Our Ref: X13044
Your Ref: SEPP (Western Sydney Employment Area) 2009 - Transport and Arterial Road Infrastructure Plan Map
Contact: Peter Lee

Submission to Department of Planning & Environment - Amendment to SEPP (Western Sydney Employment Area) 2009 - Transport and Arterial Road Infrastructure Plan Map – Southern Link Road Network (SLRN)

Figure 2: Location of proposed Capitol Hill Drive extension (Source: Figure 3-4 BSEA Structure Plan proposed road network, Broader WSEA SLRN – Options refinement)

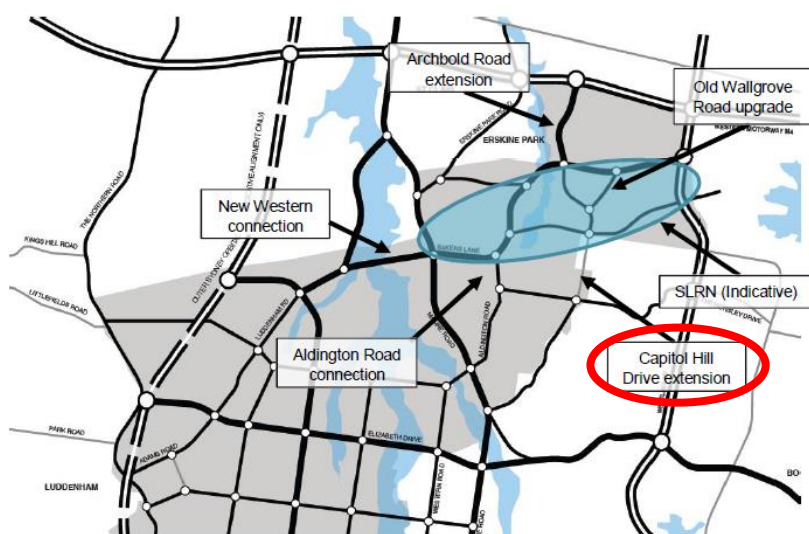
The proposed Capitol Hill Drive extension, as shown above, is not supported for two reasons. Firstly, this extension will be a sub-arterial connection and will connect industrial areas with rural/residential areas ultimately linking into the road network further south. This extension will offer another route for industrial vehicles to use however this is through existing rural/residential land. The extension would encourage industrial traffic to utilise this road but also rural/residential traffic. This becomes an issue of safety as rural/residential and industrial traffic should be separated where practical.

Secondly, CSR Pty Limited currently have a development application (DA 893.1/2013) for the subject site under assessment by Fairfield Council for an industrial subdivision. The Capitol Hill Drive extension is proposed south through the site therefore requiring redesign of the development of the Site.

- Removing the Capitol Hill Drive extension due to potential conflict of industrial traffic using this route through rural residential areas and vice versa, the residential traffic utilising the extension and driving through industrial areas.

Figure 4: Potential local access intersections with the SLRN (Source: Figure 4-14 Potential locations of local access intersections SLRN – Options Refinement Report)

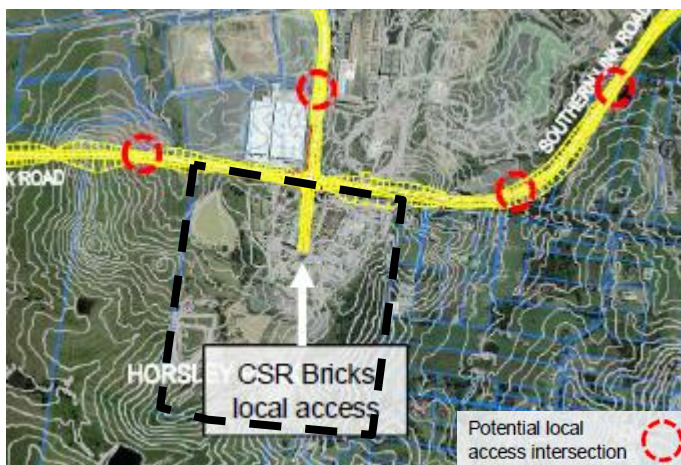
This submission objects to the control stating that 400-500m is required between intersections including a local access intersection (Clause 4.3.2 Local access intersection). This clause states that the SLRN will include consolidated signalised intersections between arterial road intersections to provide access to and from local developments as shown in Figure 4.

The SLRN – Options Refinement Report states under Clause 4.3.2 Local access intersections that “*spacing of approximately 400-500m between intersections is proposed to balance access to developments with the overall permeability of the SLRN. Figure 4 [excerpt of SLRN – Options Refinement Report (Figure 4-14)] indicates the proposed locations of local access intersections based on the preferred spacing and known opportunities and constraints in the area*”.

Consequently, this submission is objecting to Clause 4.3.2 local access intersection spacing requirements of between 400m and 500m from intersections. It is suggested that the temporary intersection could ultimately become a left in/left out access arrangement pending the construction of the 4th leg of the SLRN/Mamre Road intersection providing access into the CSR site.

- Permitting flexibility within the local access intersections spacing requirements to permit a temporary access arrangement to service Stages 1 and 2 of the proposed industrial subdivision for CSR's site until such time as the 4th leg of the SLRN/ Mamre Road intersection can be constructed and this access arrangement become a left in/left out arrangement only.

Figure 5: Submitted subdivision plan (DA 893.1/2013)

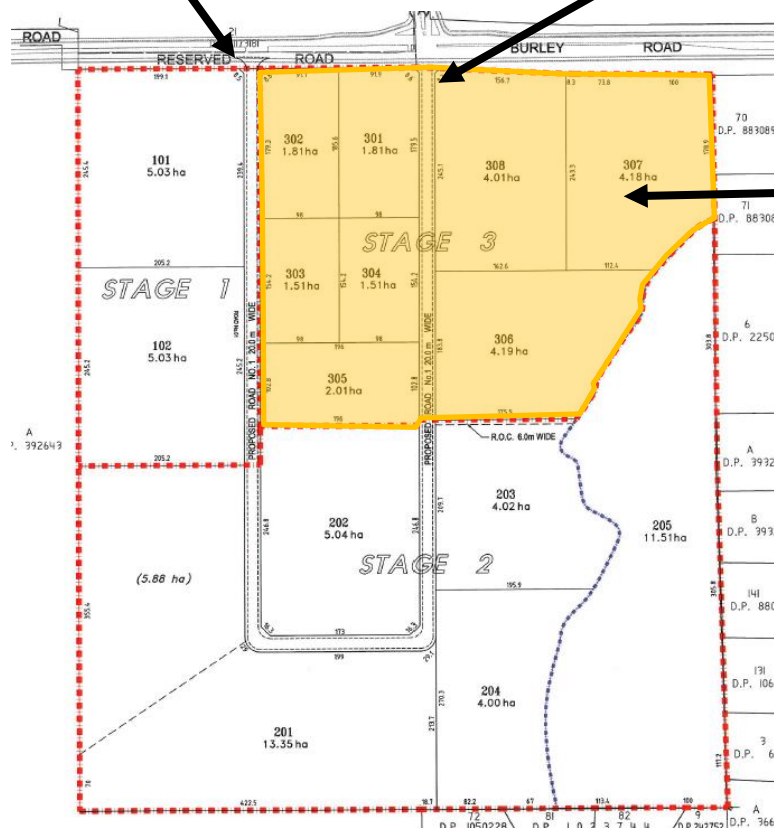
CSR have no objections to the 4th leg of the Southern Link Road intersection design providing local access to the CSR site however the 4th leg is situated over the existing brickpit. The proposed subdivision application (DA 893.1/2013) is a three staged subdivision application to progressively fill the site and facilitate the development of Stages 1 and 2 for industrial purposes while permitting the continued operation of the brick factory until such time as CSR decide to cease operation and develop the land in Stage 3. An excerpt of the subdivision plan is shown in Figure 5.

Temporary intersection

Location of 4th leg of SLRN/Mamre Road intersection

As shown in Figure 5, the 4th leg of the SLRN/Mamre Road intersection will be within Stage 3 of the proposed development which will not be constructed until such time as CSR decide to cease the operation of the brick making factory being in some 10 years. As such, an intersection is required to service Stages 1 and 2 of the proposed industrial development. In accordance with Figure 4 Potential local access intersections with the SLRN, CSR's property does not contain an indicative local access point. In order to service Stages 1 and 2 a temporary access road is proposed approximately 200m from the intersection as shown in Figure 5.
